Vermont Agency of Transportation
RECEIVED
CK'D BY GFR OK'D BY
Jan. 13, 2015
RESUBMIT X
BY C. Carlson DATE 05-12-2015

# SPECIAL PROVISION, GRAS – CONCRETE COMBINATION BR.

EM14-184, PROJECT: RUTLAND CITY, BRF 3000(16)
TOWN OF RUTLAND, RUTLAND COUNTY, VT

| HOLE POSITION CHART | |

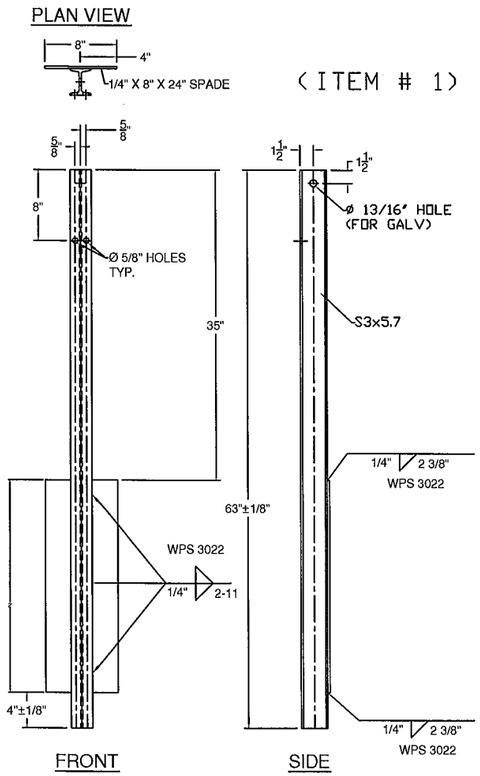
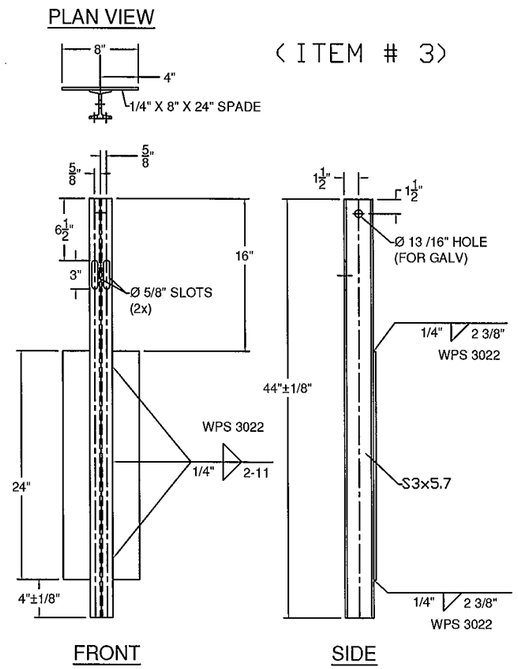
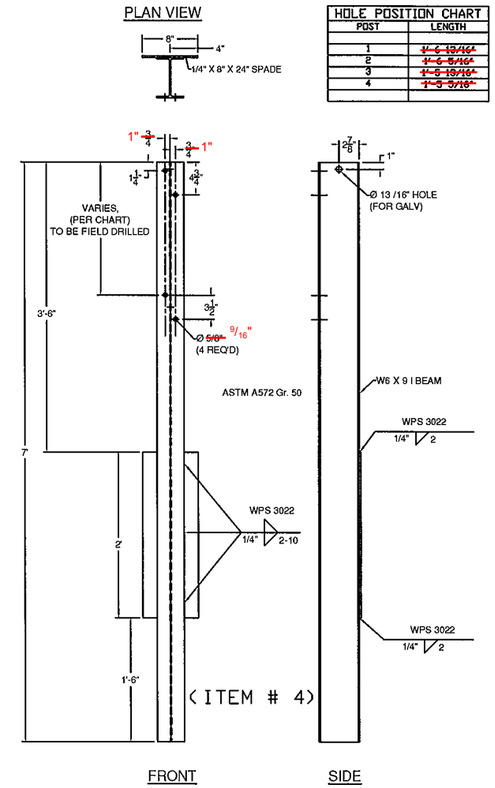
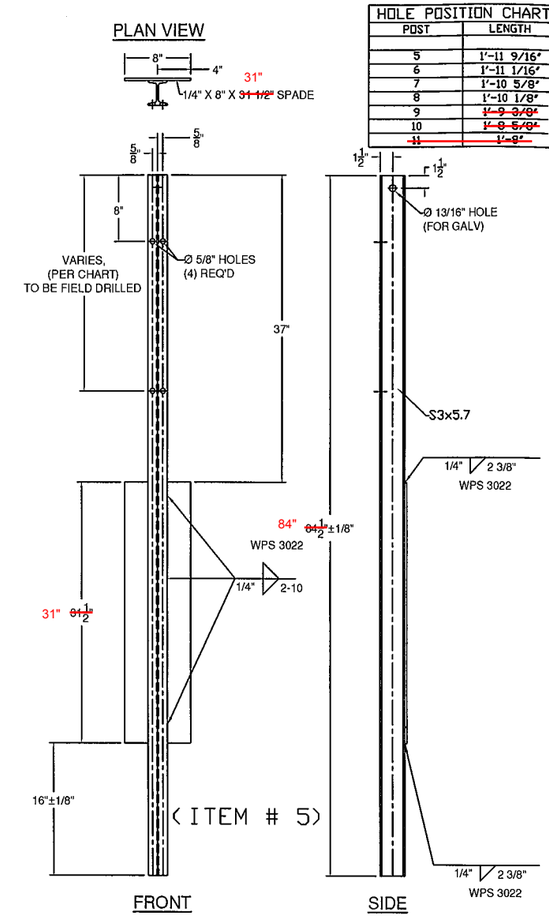
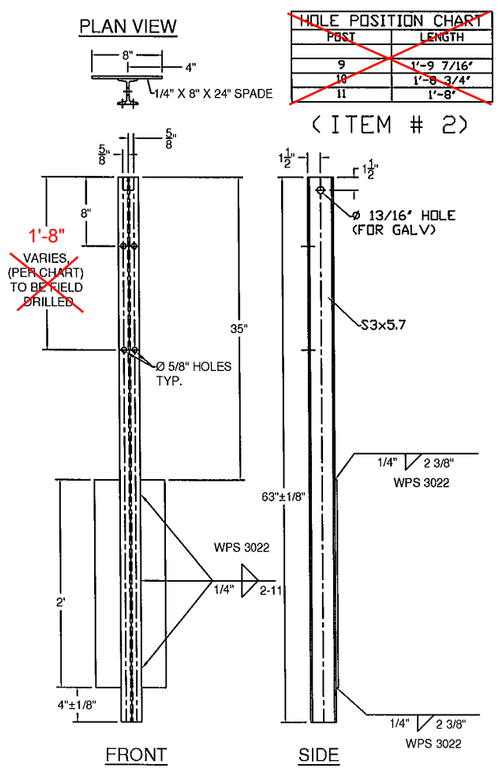
| HOLE POSITION CHART | |
|---|---|
| 1 | ~~1'-6 13/16"~~ 1'-6 11/16" |
| 2 | ~~1'-6 5/16"~~ 1'-6 1/4" |
| 3 | ~~1'-5 13/16"~~ 1'-5 3/4" |
| 4 | ~~1'-5 5/16"~~ 1'-5 1/4" |

| HOLE POSITION CHART | |
|---|---|
| 9 | ~~1'-9 3/8"~~ 1'-9 7/16" |
| 10 | ~~1'-8 5/8"~~ 1'-9 11/16" |
| ~~11~~ | ~~1'-8"~~ |

| HOLE POSITION CHART | |
|---|---|
| ~~9~~ | ~~1'-9 7/16"~~ |
| ~~10~~ | ~~1'-8 3/4"~~ |
| ~~11~~ | ~~1'-8"~~ |

SPLICE TUBE - FIXED

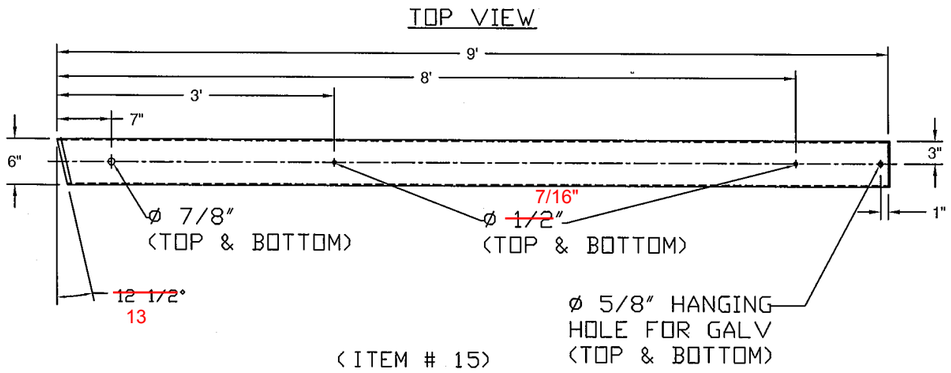
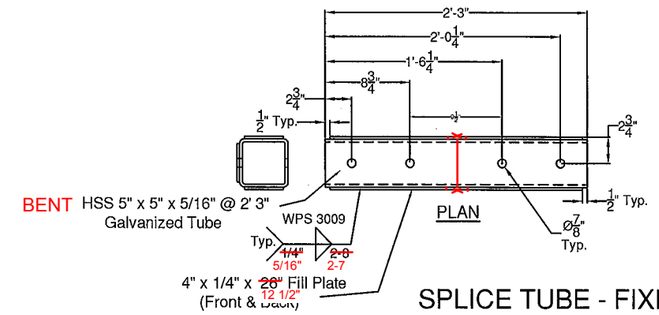
DETAILER: THIS END UP. SPLICE TUBE NEEDS TO BE BENT TO FIT INTO TOP RAIL SECTIONS AT POST 11. FILL PLATES BECOME TWO PIECES.

ITEM 16A

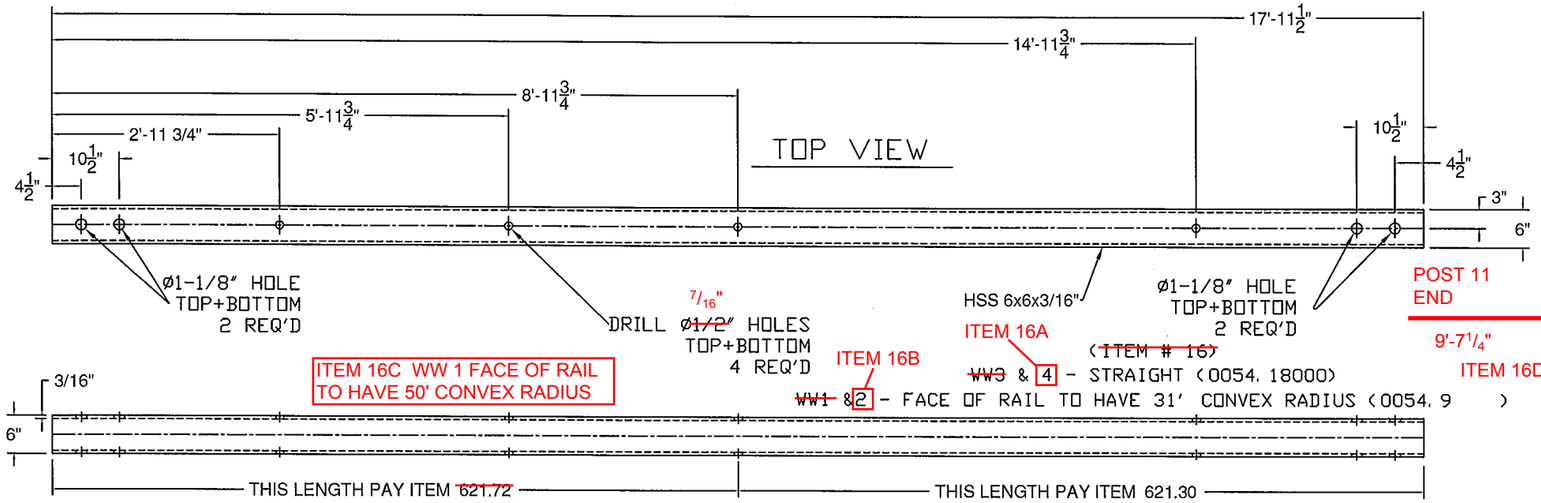
~~(ITEM # 16)~~

~~WW3~~ & 4 - STRAIGHT (0054. 18000)

~~WW1~~ &2 - FACE OF RAIL TO HAVE 31' CONVEX RADIUS (0054. 9 )
